Case File Number: PLN17101

Project Location:	10-10 th Street (Oakland Civic Auditorium)
Assessor's Parcel Numbers:	018 045000500
Proposal:	To rehabilitate the vacant Oakland Civic Auditorium that consists of interior and exterior building alterations, including site modifications to the walkways, landscaping and parking lot to facilitate new commercial uses and improve the historic entertainment venues.
Project Applicant/ Telephone:	Orton Development, Inc. (510) 428-0800
Property Owner:	City of Oakland
Case File Number:	PLN17101
Planning Permits Required:	Major Conditional Use Permit for Extensive Civic Impact; and Regular Design Review for site and building alterations.
General Plan: Specific Plan:	Central Business District Lake Merritt Station Area District
Zoning:	D-LM-4 Lake Merritt Station Area District Mixed Commercial
Environmental Determination:	Under Review
Property Historic Status:	OCHS A1+, Designated Historic Property API, Area of Primary Importance (Lake Merritt)

LANDMARKS PRESERVATION ADVISORY BOARD

- A. Design Plans, dated January 15, 2019

2 NORTH ELEVATION - PROPOSED
1" = 30'-0"

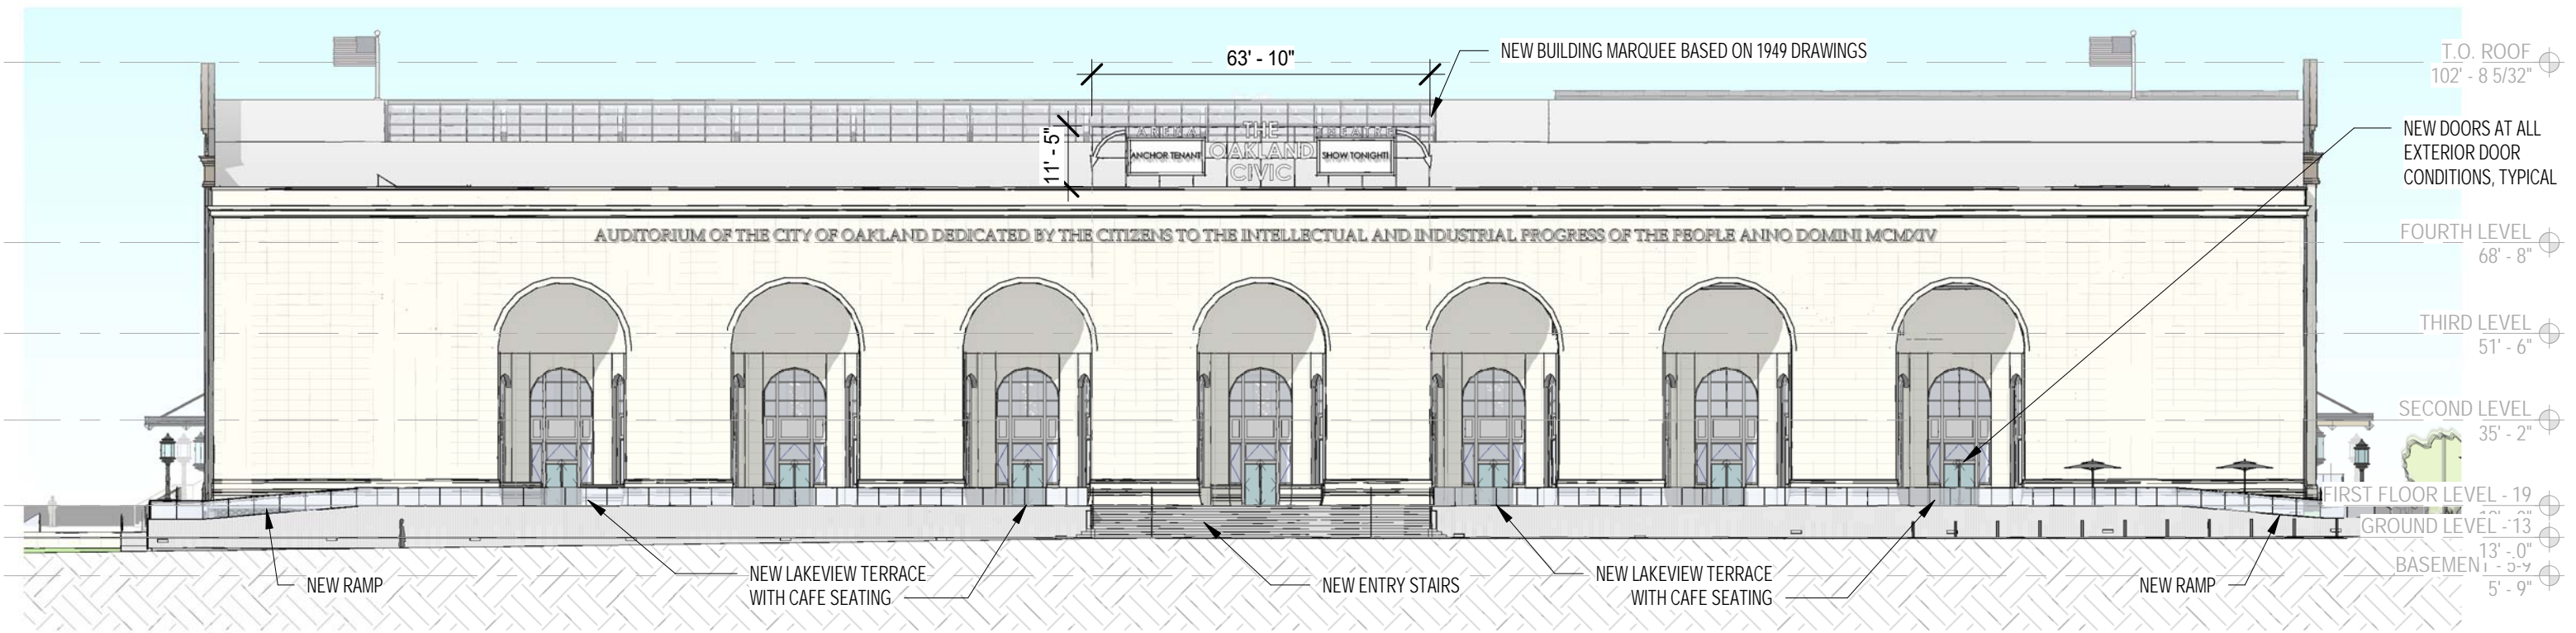
The Oakland Civic Auditorium is considered a City Landmark because of its significant historical, architectural and cultural value. The proposal would replace the north concrete entries of the OCA with a raised terrace that extends approximately 400 feet along façade of the building. The seven-foot tall concrete terrace with a three and one-half foot tall glass guardrail would potentially visually obstruct the lower area of the prominent arched niches and entry stairs when viewed from Lake Merritt Boulevard and the Lake Merritt shore. Staff believes that the proposal would create an unnecessary impairment of the physical features that contribute to highest level of recognition of historic significance for the OCA.

Staff would support a plan for a larger terrace in front of the OCA if it is built at grade. The applicant may consider building a forecourt between the building and the parking lot. The forecourt would include a wider entry pathway that connects OCA from Lake Merritt Boulevard. The forecourt and pedestrian pathway could include distinctive paving materials, landscape barriers or planters, outdoor furniture, and bollard lights to create a separation from the parking lot. Staff believes that a well-designed forecourt would be attractive and inviting to the public while enjoying the grand views of the historic building.

- Replace the raised terrace with one that is at grade level and distinctive.
- Place the new terrace access ramps at the ends of the front building.
- Provide a simple and subtle design to the surface parking.
- Make the pathway entry in the parking lot more prominent and inviting.
- Clarify the pathway from the promenade to Lake Merritt Boulevard.

AXONOMETRIC DIAGRAM OF TERRACE

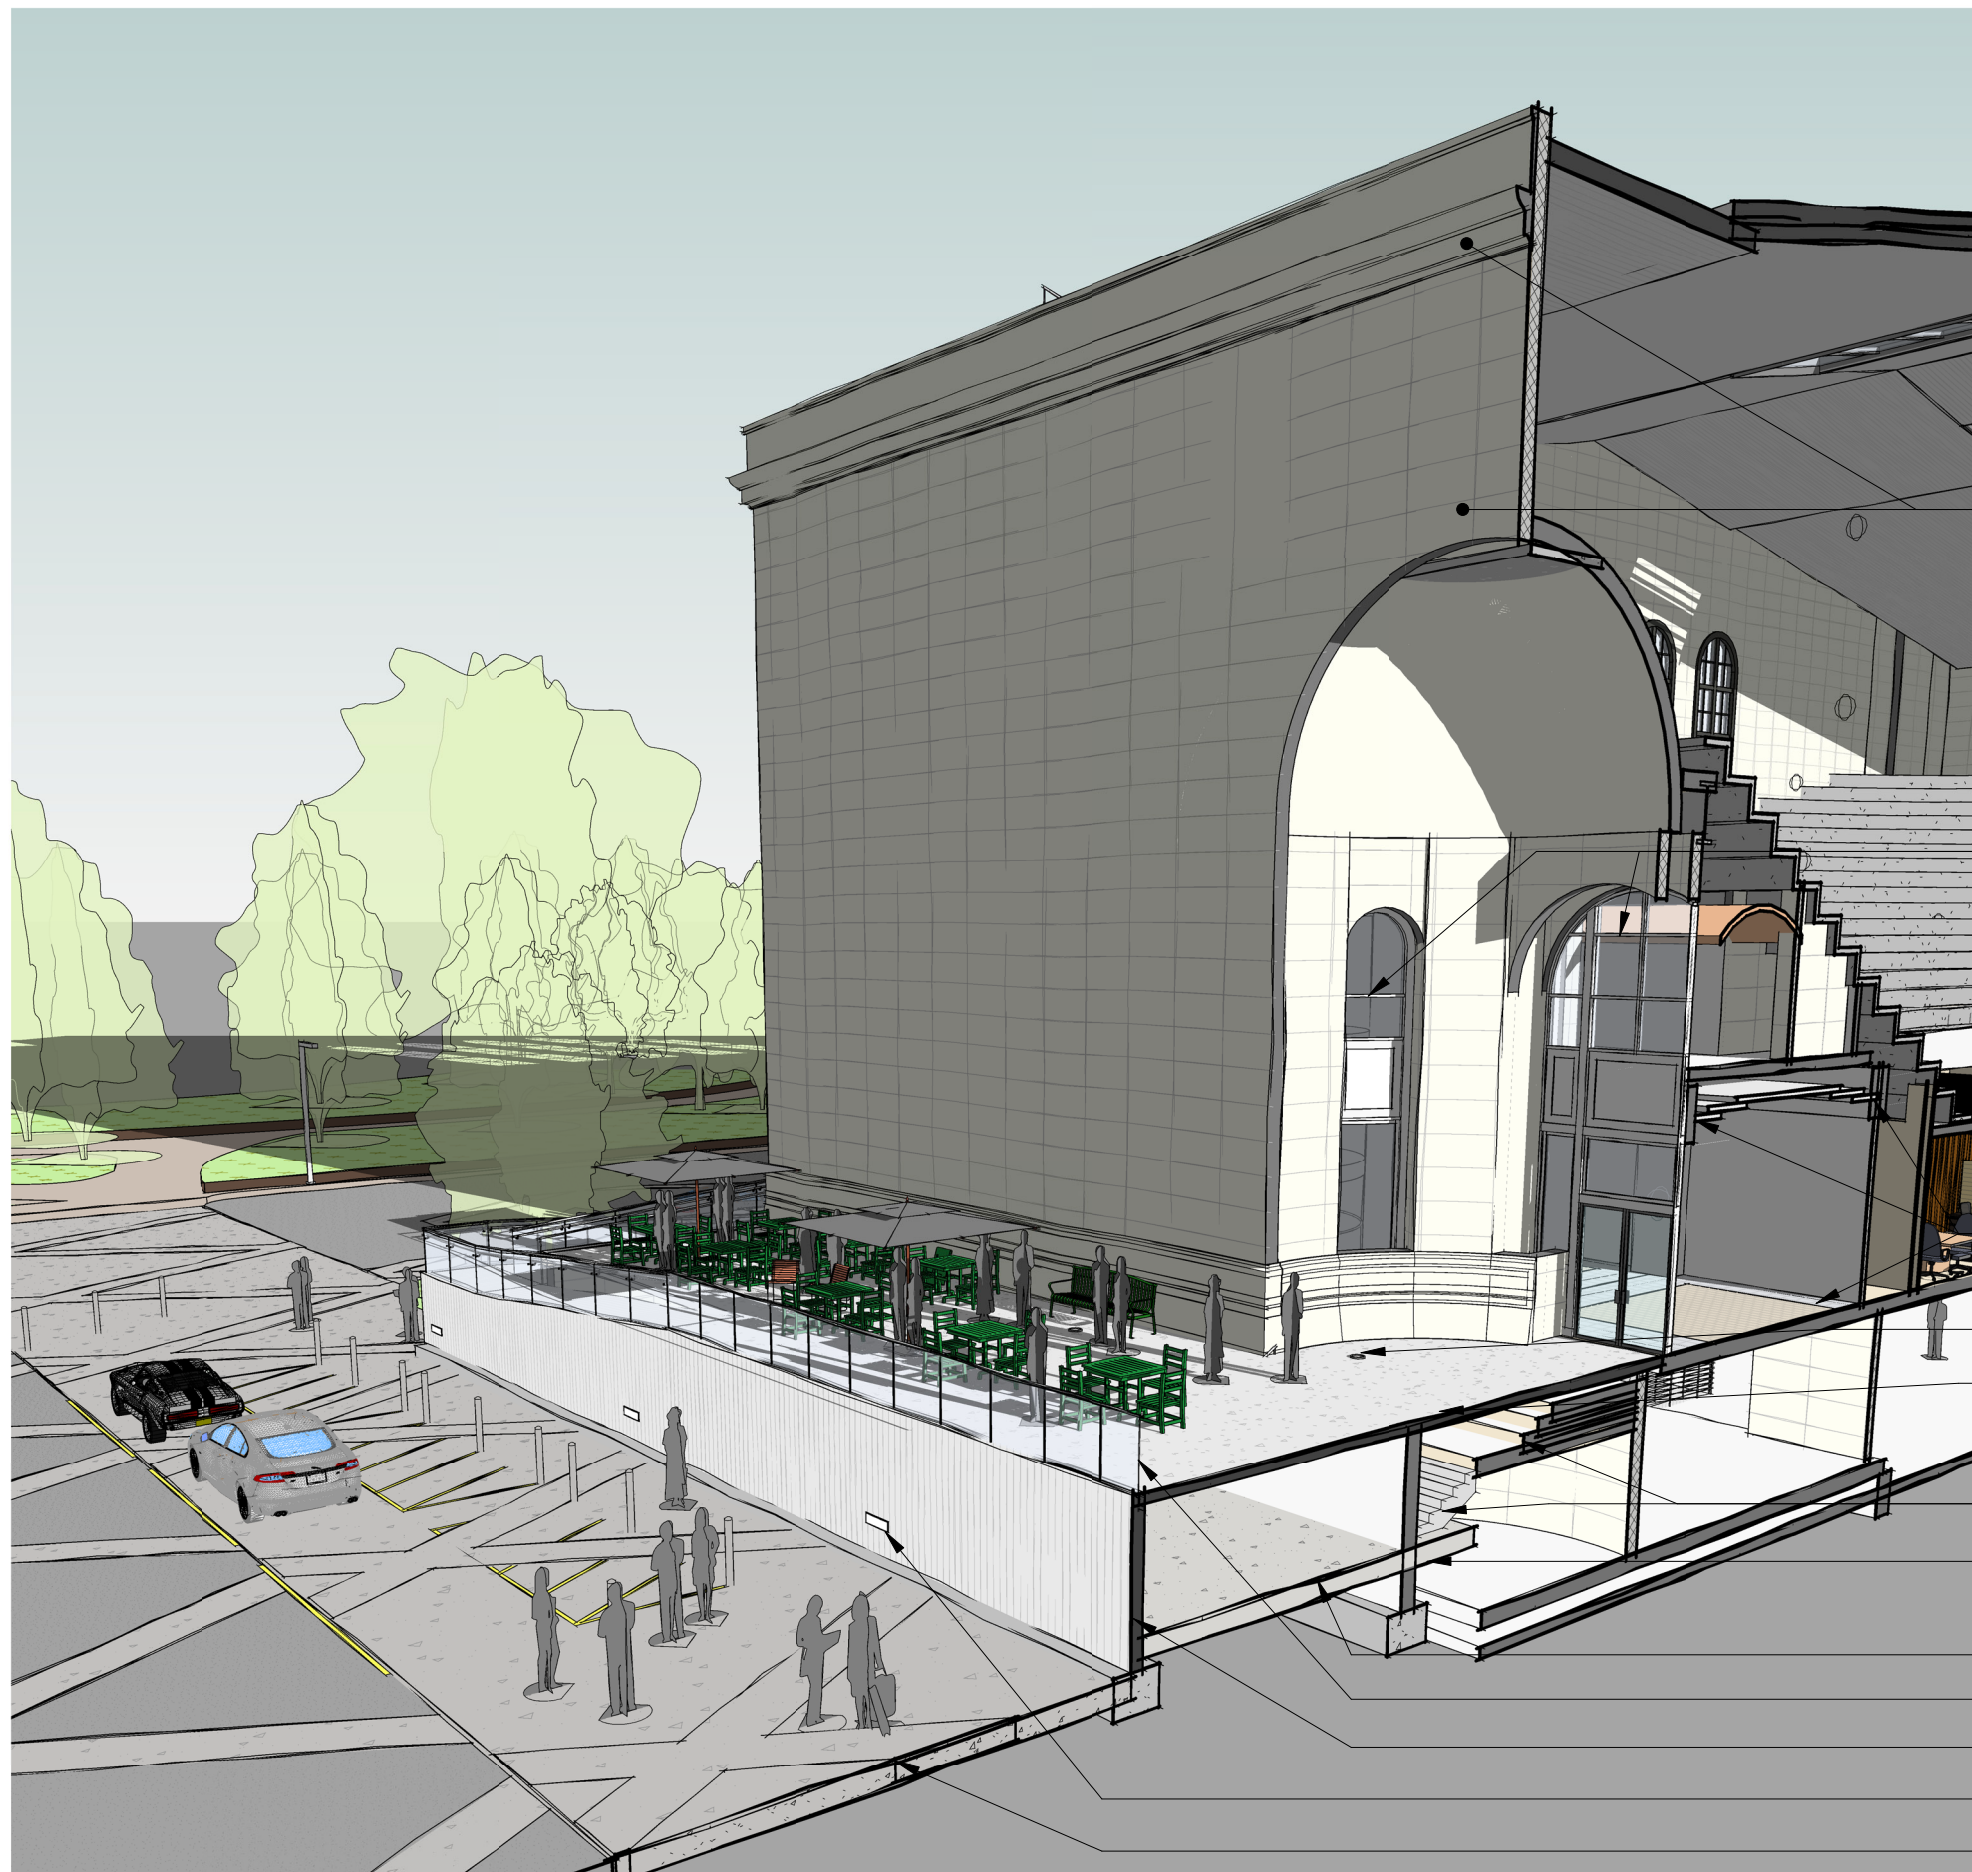
The proposal for a raised concrete terrace would visually undermine the lower facade of the three-story tall masonry building, and each of the separate entry stairways. The approximately seven-foot-tall concrete terrace would be structurally tied to the main building. The terrace would be added along the building facade, and contain a sandblasted finish face with steel and glass guardrail. The location, size and design of the raised terrace diminishes the physical features that contribute to highest level of recognition of historic significance for the OCA.

The proposal would add a contemporary style raised concrete terrace along the frontage of the OCA. The new terrace would have its own foundation and be tied to the structure of the building. The terrace would not reuse the existing, bottom portion of the niches; however, it would cover the affected area. The new addition differs from the style of the historic building, and if removed, it may compromise the lower building façade.
